**PRODUCT
NEWS****Product Discontinuation
Notices**Issue Date
June 30, 2026**Product Discontinuation**

Programmable Terminal

**NA5-□□W□□□□-V1****Recommended Replacement**

NA5-□□W□□□□-V2**[Final order entry date]**

[Dimensions]

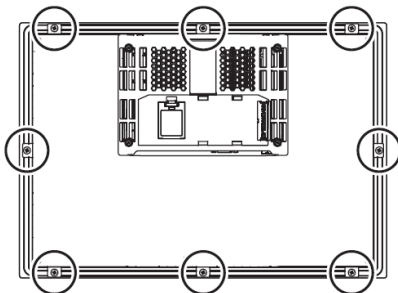
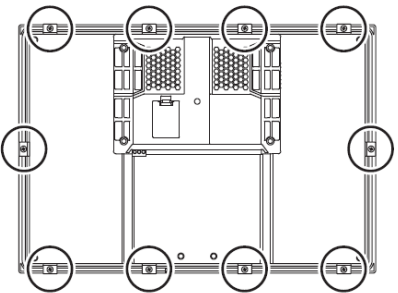
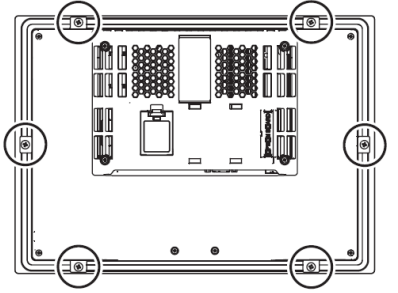
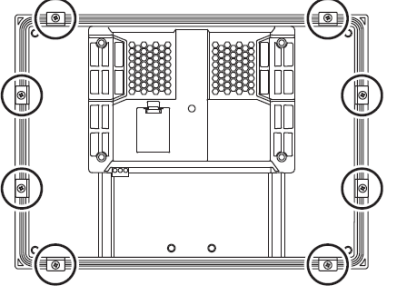
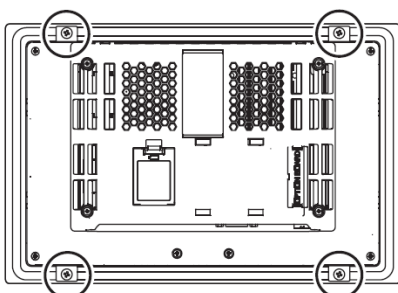
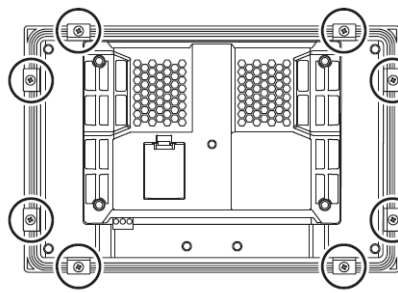
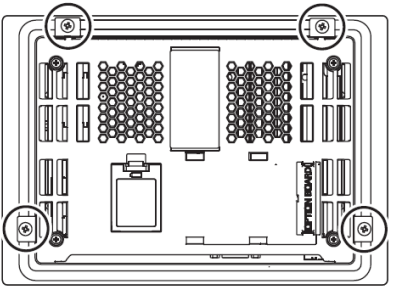
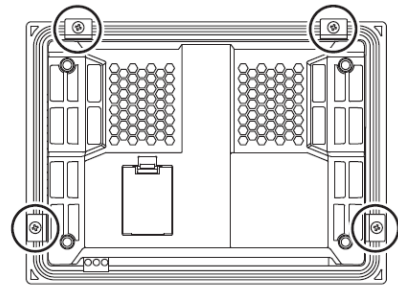
Item	Product discontinuation Model NA5-□□W□□□□-V1	Recommendable replacement Model NA5-□□W□□□□-V2
15 inches	420 × 291 × 69 mm (width × height × depth)	414 × 287 × 69 mm (width × height × depth)
12 inches	340 × 244 × 69 mm (width × height × depth)	333 × 240 × 69 mm (width × height × depth)
9 inches	290 × 190 × 69 mm (width × height × depth)	283 × 185 × 69 mm (width × height × depth)
7 inches	236 × 165 × 69 mm (width × height × depth)	220 × 160 × 69 mm (width × height × depth)

[Mounting dimensions]

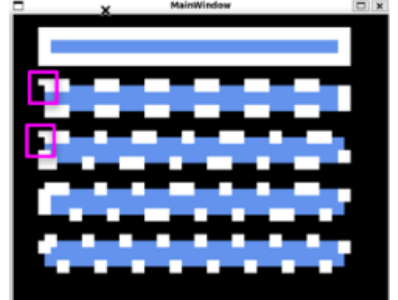
Item	Product discontinuation Model NA5-□□W□□□□-V1	Recommendable replacement Model NA5-□□W□□□□-V2
15 inches	NA5-15W□□□□-V1 	NA5-15W□□□□-V2 
12 inches	NA5-12W□□□□-V1 	NA5-12W□□□□-V2

Item	Product discontinuation Model NA5-□□W□□□□-V1	Recommendable replacement Model NA5-□□W□□□□-V2
9 inches	NA5-9W□□□□-V1 	NA5-9W□□□□-V2 
7 inches	NA5-7W□□□□-V1 	NA5-7W□□□□-V2
